St. Johns River Water Management District

DATE: August 26, 2019
TO: Prospective Respondents
FROM: Pam Paulk, Sr. Procurement Specialist
SUBJECT: Addendum #2 to Invitation for Bids 34718 Lake Apopka North Shore Phase 4 Pump Station

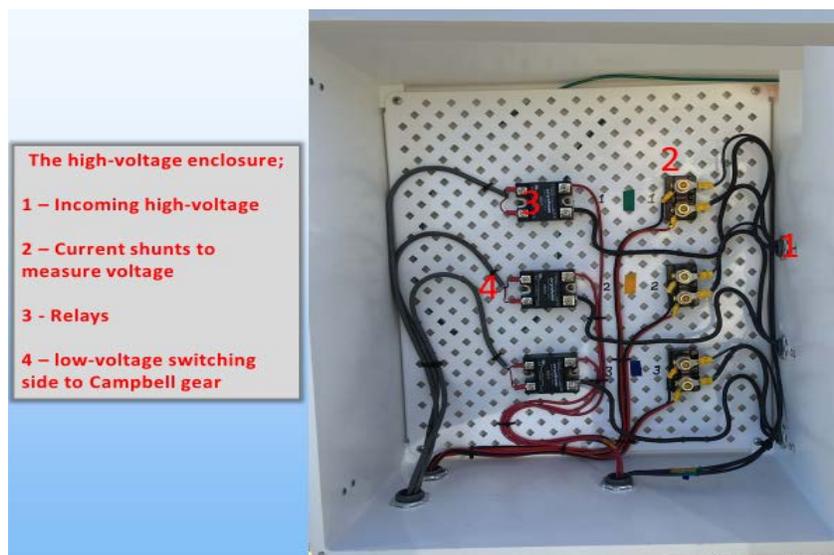
Q.2.: Please provide a specification and the function for the relay panel drawing E04.
A.2.: The relay panel is a standard requirement for the District. Attached is a photo of a similar project. Purpose of the relay panel is to isolate the high voltages from the 12 V RTU. See the Telemetry Riser and notes on Drawing E04.

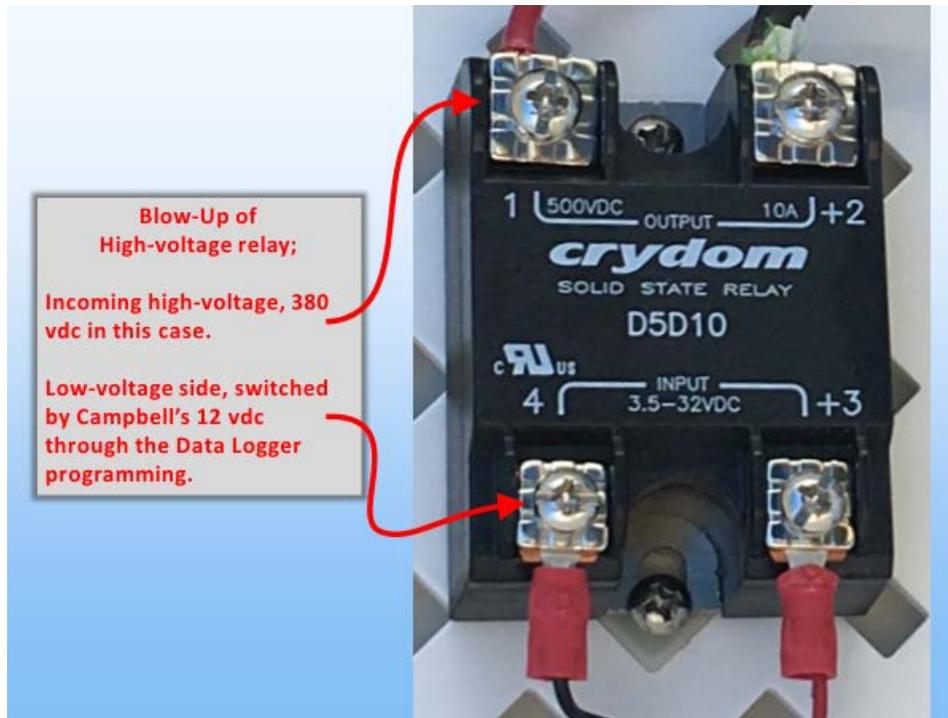
- Q.4.: There looks to be about 40 LF of vinyl sheet piling on drawing No. C03 but I do not see a specified model number or length of pile. Please provide this information.

- A.4.: A replacement in like kind to the original capped vinyl sheet piling end walls around the flashboard risers is intended. A specific vinyl sheet piling manufacturer and model number is not specified. See Note 1 on Drawing No. C03 for minimum requirements of the vinyl sheet piling. Respondents may assume vinyl sheet piling length of 15 ft. A photo of a similar installation is provided below for bidder's reference.
